Office Action Summary	Application No. 18/698,915	Applicant(s) MORISHIMA et al.	
	Examiner Eric K Wong	Art Unit 2874	AIA (First Inventor to File) Status Yes

DETAILED ACTION

5. Claim(s) 1-2 and 4-7 is/are rejected under 35 U.S.C. 103 as being unpatentable over Shimikawa (cited in prior action) in view of US 2003/0215191 to Inagaki et al.

FIG. 4A

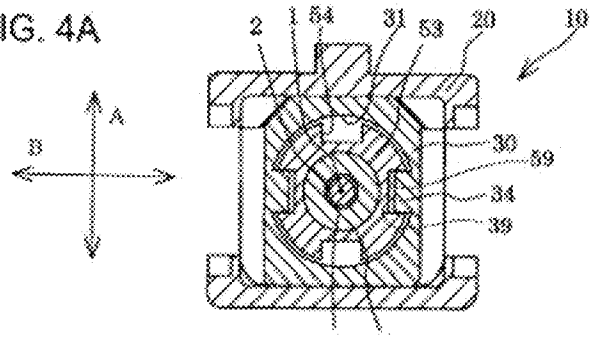
Inagaki discloses a round-type profile having a recess between two contact points (figure 4A).

It would have been obvious to one having ordinary skill in the art to swap the recess portion to be between two contact points as taught in Tiara in the square-type shape of Shimikawa as a design choice for a change in size, shape, rearrangement or reversal of parts. *In re Japikse*, 86 USPQ 70, *In re Rose*, 105 USPQ 237 (CCPA 1955), *In re Einstein*, 8 USPQ 167.
